Franklin County Board of Commissioners Rezoning Hearing

STAFF REPORT

Case ZON-13-04

Summary
The applicant is requesting to amend an existing Planned Industrial Park (PIP) District to allow the construction of a 10,600 +/- square foot building addition. The request is compatible in nature and intensity with other industrial uses in the surrounding area, meets the basis of approval and is consistent with the land use recommendations of the Scioto-Franklin Neighborhood Plan and Greater Hilltop Plan Amendment. Staff recommends ***approval with conditions***.

SITE DEVELOPMENT PLAN
FOR
3180 VALLEY VIEW DRIVE
SNYDER MASONARY AND SUPPLIES

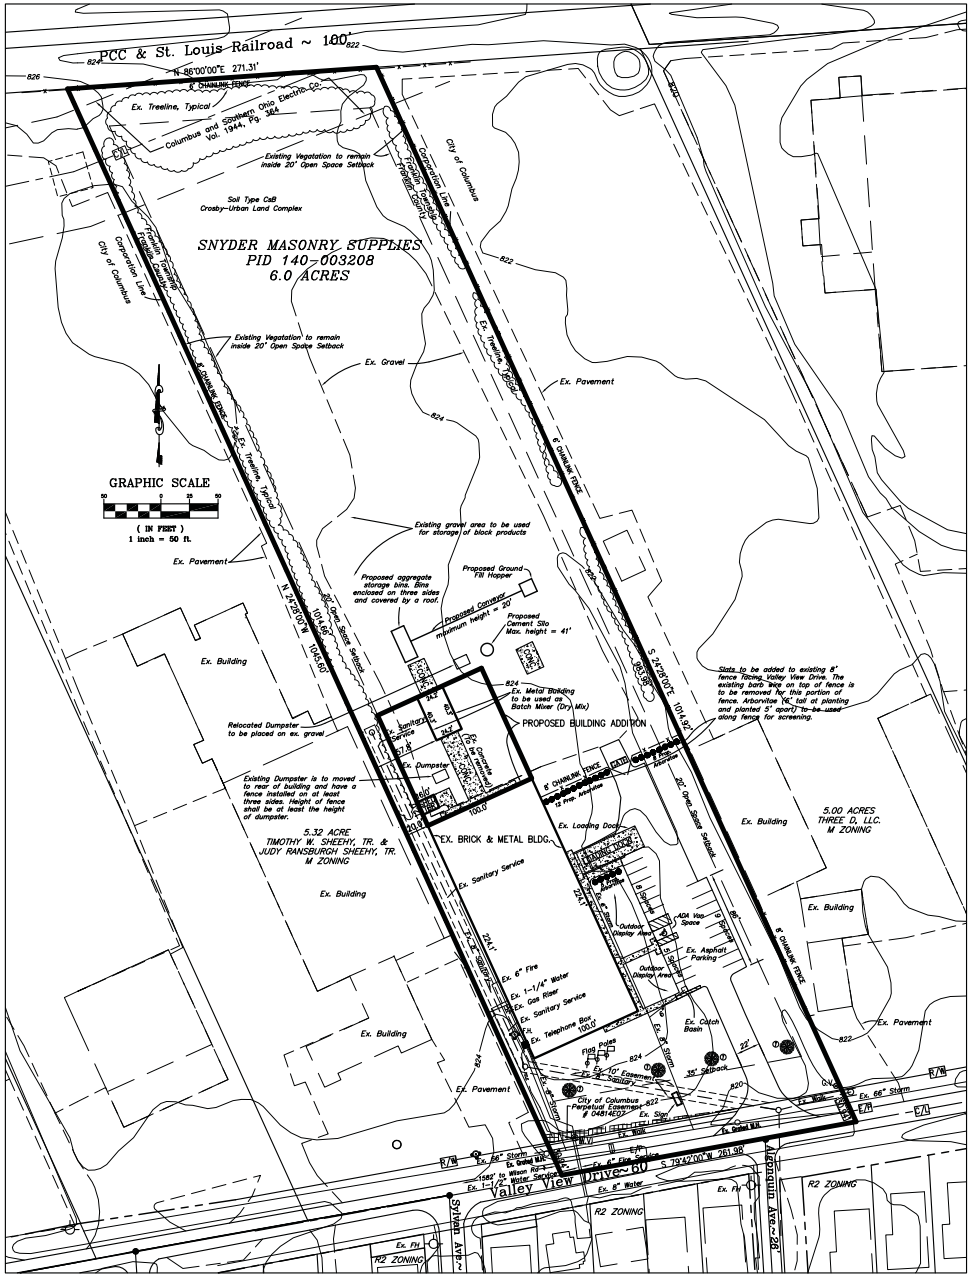
Staff recommends ***approval*** of the proposed amendment with the following conditions:

1. The applicant shall apply for and receive an approved Certificate of Zoning Compliance from the Franklin County Economic Development and Planning Department.

2. The applicant shall obtain all required permits and inspections from the Franklin Township Building Department, Franklin Township Fire Department, and City of Columbus Public Utilities Department prior to beginning construction and/or occupying the site.

3. The applicant shall install fencing, to the height of the existing dumpster, on at least three sides, to provide adequate screening and to prevent trash or debris from blowing onto adjacent properties.

4. The applicant shall install all landscaping and screening as required under rezoning case ZON-13-01.
5. The applicant shall consult with the Franklin Soil and Water Conservation District, Franklin County Engineer's Office, and Franklin Township Building Department on the design and installation of the above ground cistern and roof drainage system. The cistern shall be located to the side or rear of the building addition and shall be screened so that it is not visible from the public right-of-way. The development plan must be updated to include the location of the above ground cistern prior to the issuance of a Certificate of Zoning Compliance.
